ADDENDUM NO. 1 - July 27, 2020

**Louise Avenue Pavement Rehabilitation
CIP PS 18-01**

This addendum amends the Contract Drawings and Specifications for this project as follows:

CITY OF LATHROP LOUISE AVENUE WATER TRANSMISSION MAIN PROJECT (CIP PS 18-01)

SHEET NO.
W4
OF
10

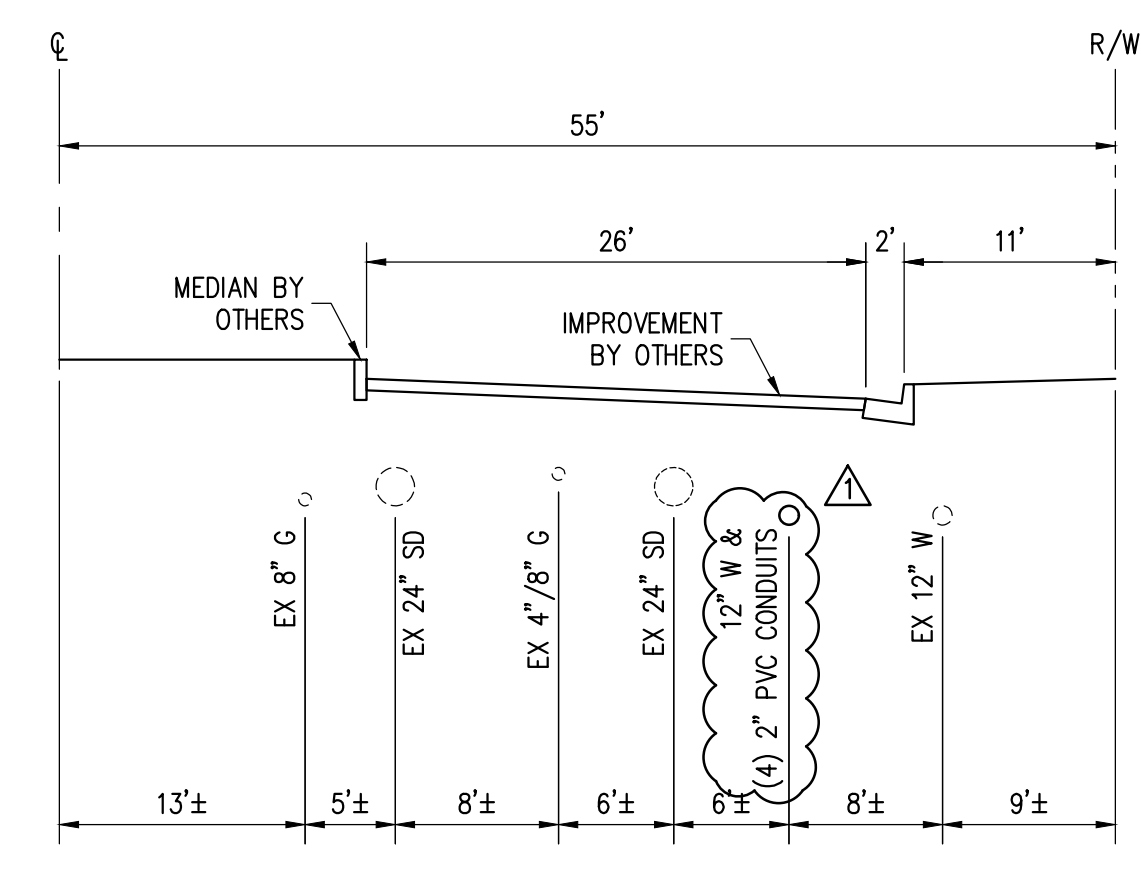
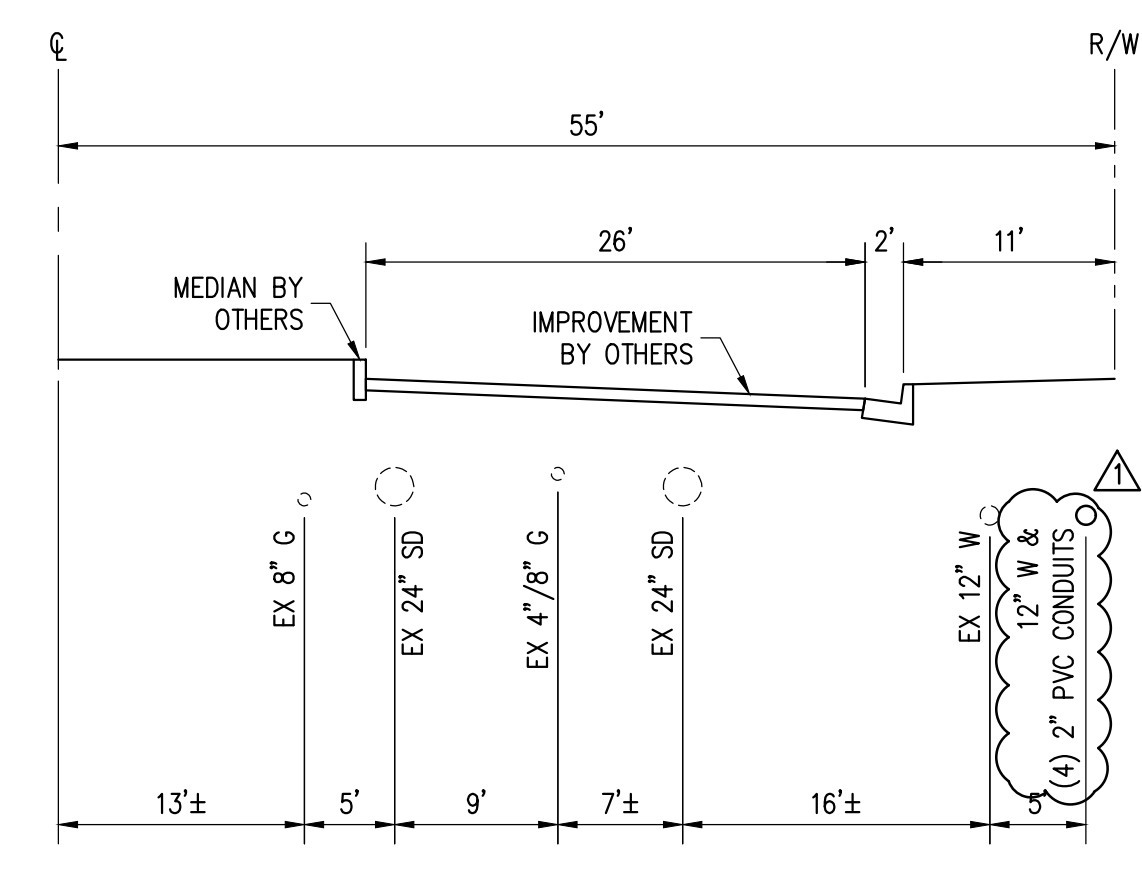
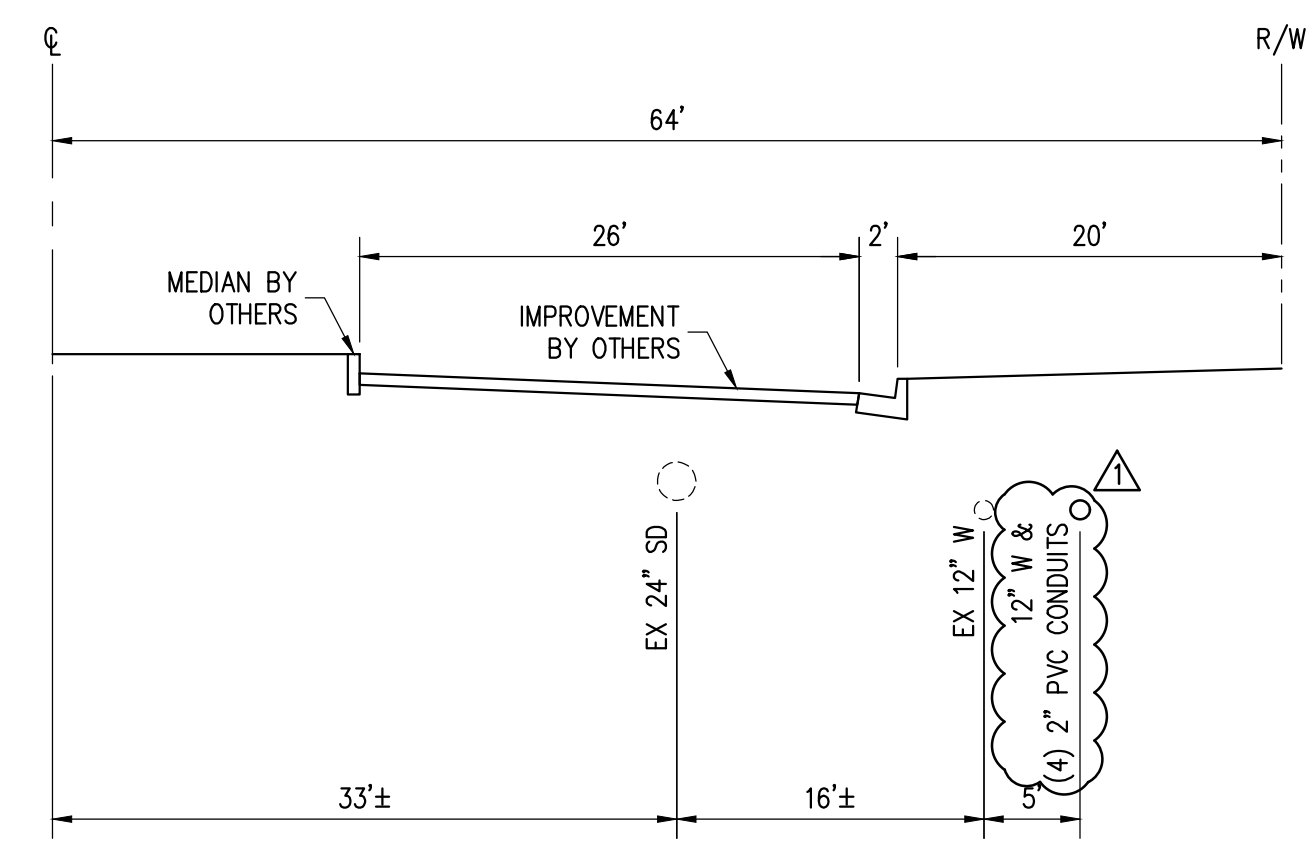
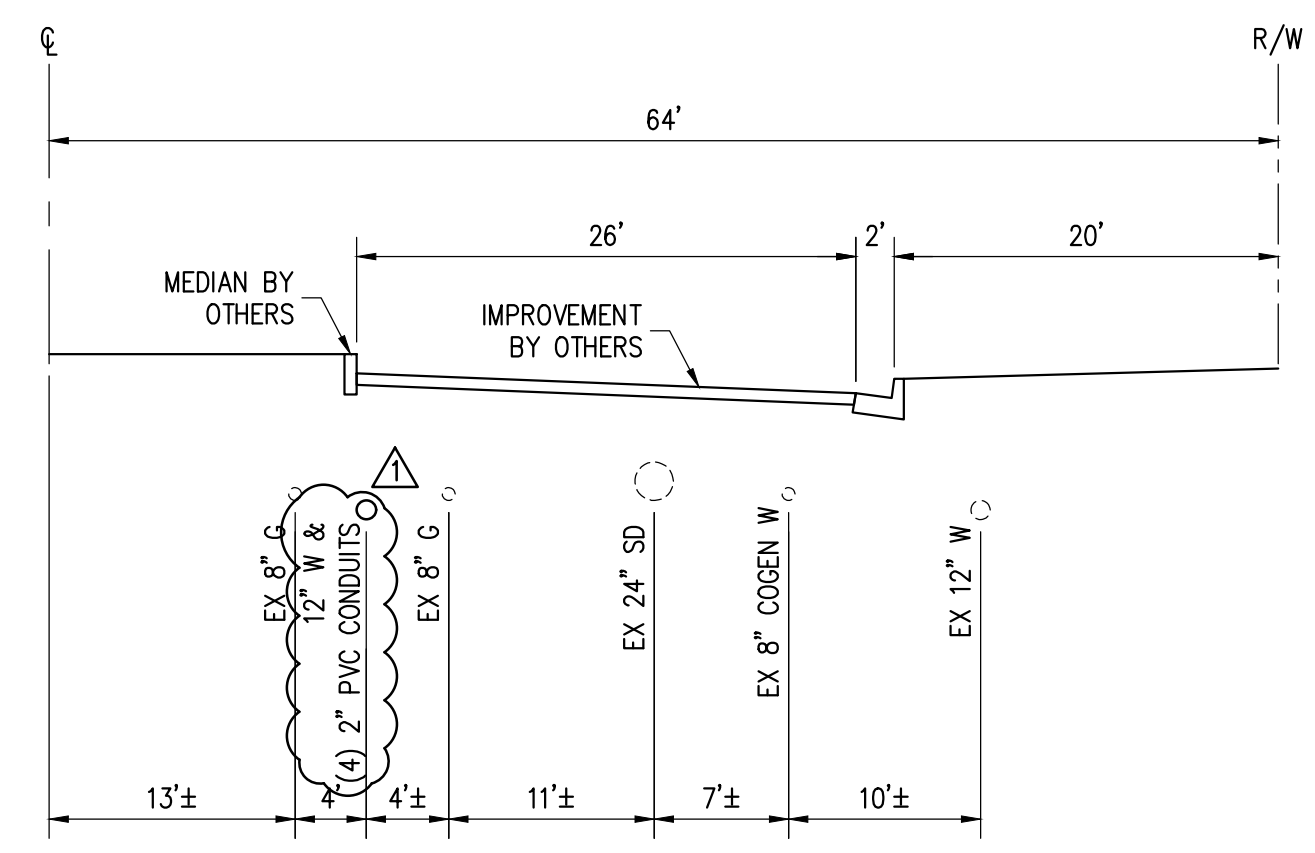
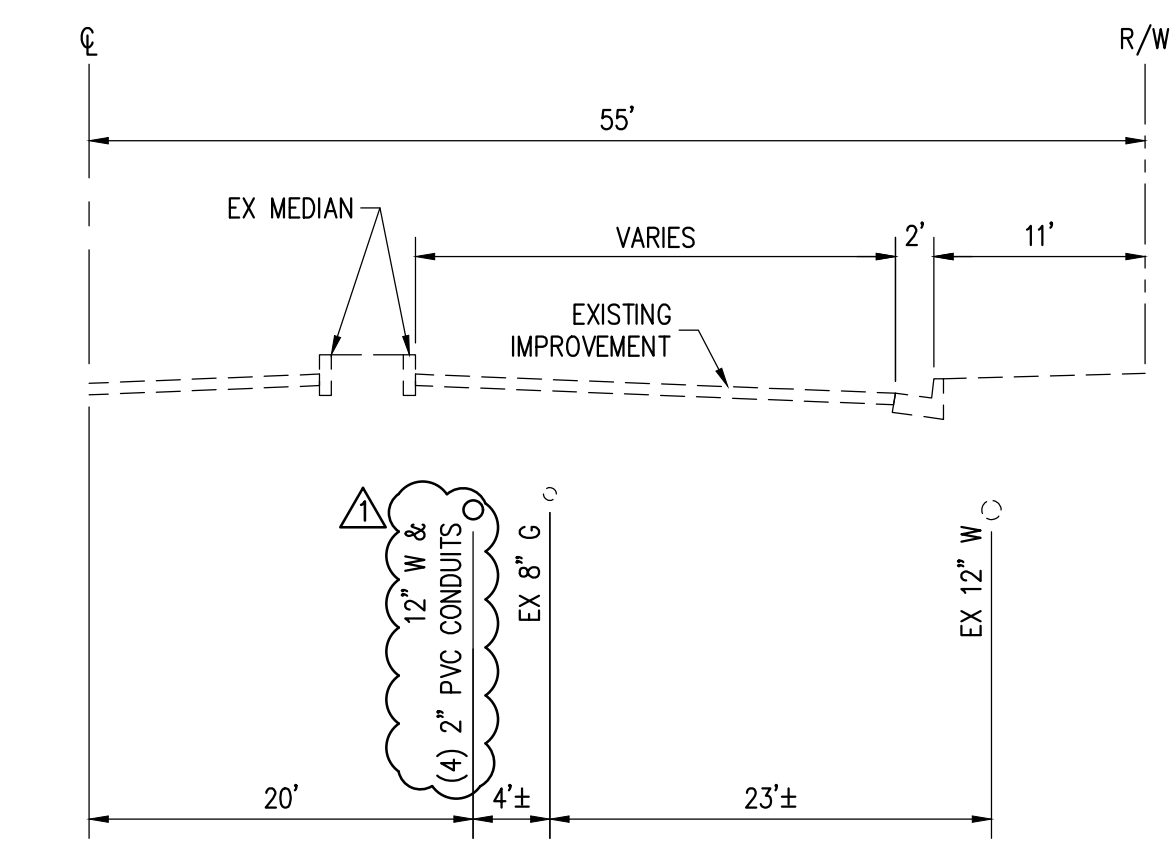
NOTE:
1. INSTALL (4) 2" PVC CONDUITS IN A 2X2 PATTERN AT THE BOTTOM OF THE SOUTH CORNER OF THE PROPOSED WATER LINE TRENCH. SEE DETAIL C ON SHEET W3 FOR TYPICAL TRENCH DETAIL.

EAST LOUISE AVENUE WATER MAIN (STA 29+00 TO STA 39+00)

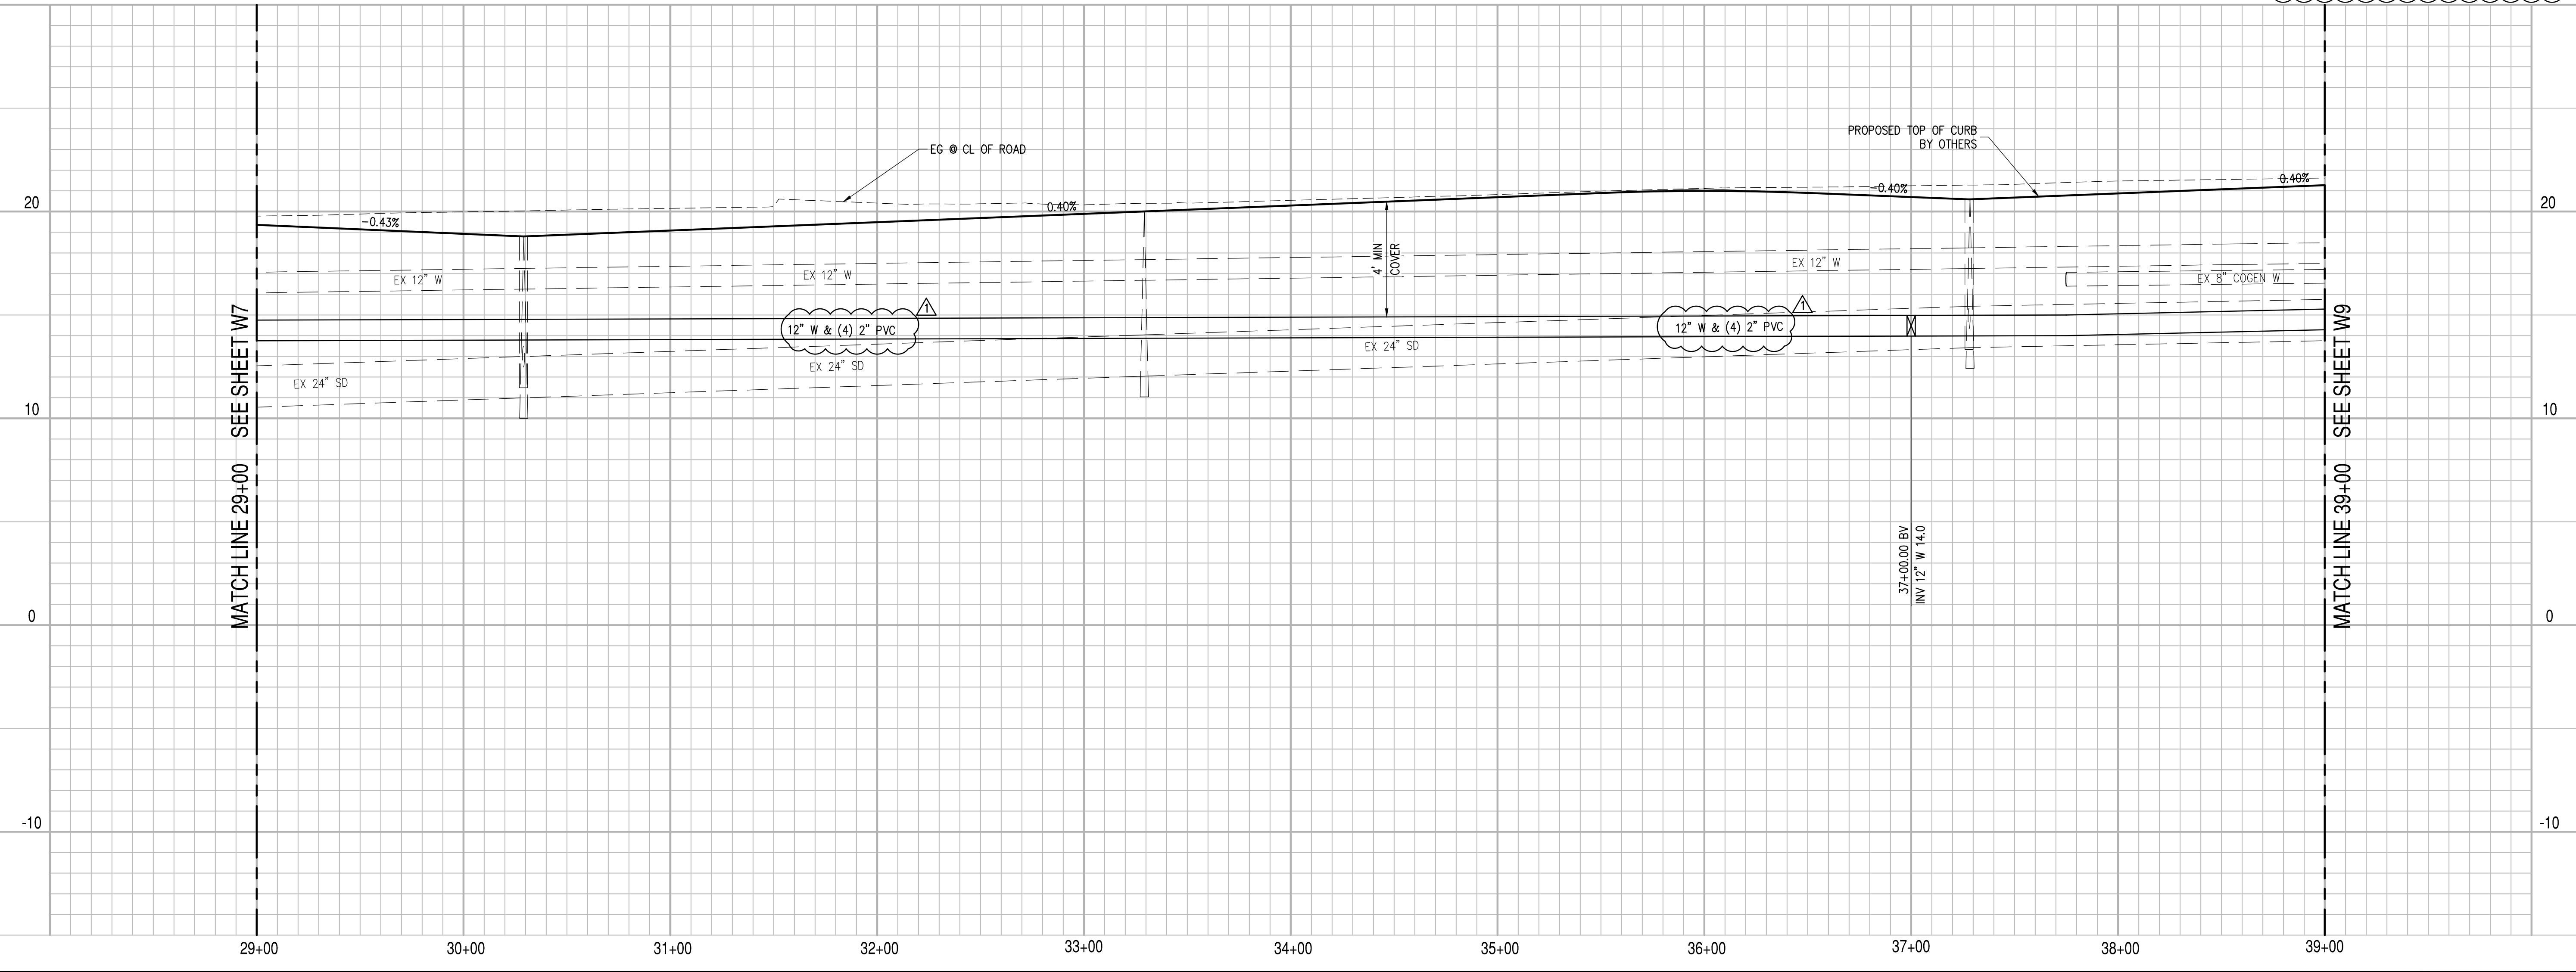
RFI 9: At Station 33+00 to 34+00 the new water line is shown crossing an existing valley gutter, bus stop and signal pole. Can the water line alignment be adjusted in this location to avoid these existing facilities? If not, under which bid item will replacement of existing valley gutters and bus stops be paid for?

A 9: Yes, the water line alignment can be adjusted in this location to avoid the existing facilities.
